MIL-F-18251C  
 AMENDMENT - 2  
 12 June 1970  
~~SUPERSEDING~~  
 Amendment - 1  
 26 January 1968

MILITARY SPECIFICATION  
 FLUXES, WELDING, SUBMERGED ARC PROCESS  
 CARBON AND LOW-ALLOY STEEL APPLICATION

This amendment forms a part of Military Specification MIL-F-18251C, 24 October 1967, and is mandatory for use by all Departments and Agencies of the Department of Defense.

Figure 1 - Groove weld test plate. p. 16

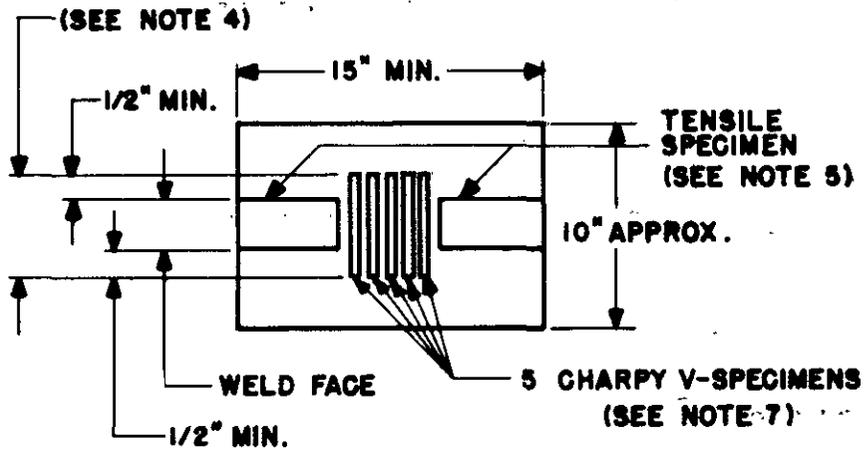
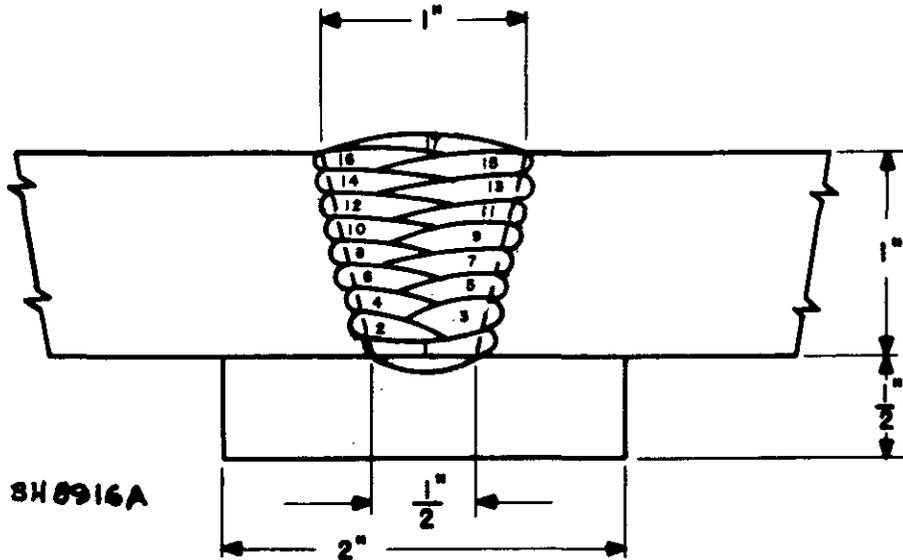
Figure 1: Delete and substitute the attached figure.
